GROUP **Body**	MODEL **Sedona VQ**
	NUMBER **040 [Revised]**	DATE **February 2009**

TECHNICAL SERVICE BULLETIN

POWER SLIDING DOOR (PSD) CONTROL MODULE REPLACEMENT

LH (driver's side) PSD drive unit and control module is shown here.

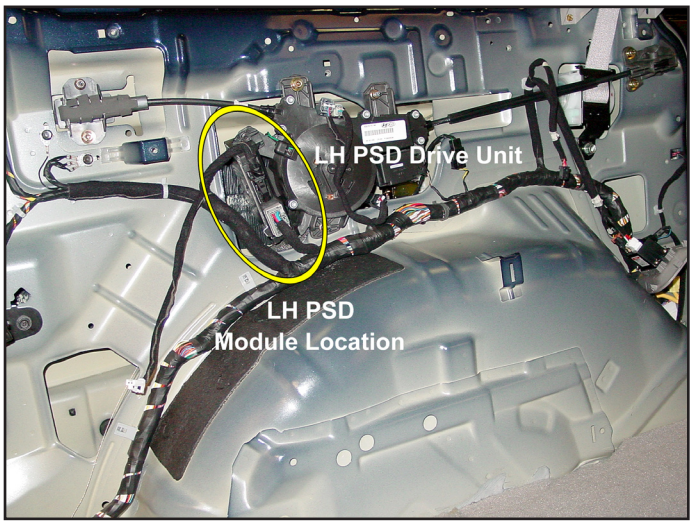
Referring to Case A or Case B, replace the PSD control modules or module as necessary with part number 95450 4D102. Follow the service procedure provided in KGIS under Body Electrical, Power Sliding Door System, Power Sliding Door Module.

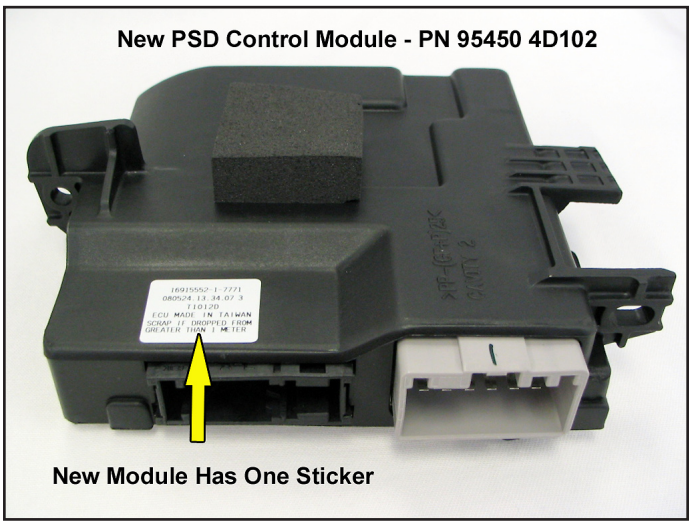
Both new control modules share a common part number (95450 4D102) and are fully interchangeable.

Original module has two small white colored stickers applied to the case.

New module only has one larger sticker applied as shown here.
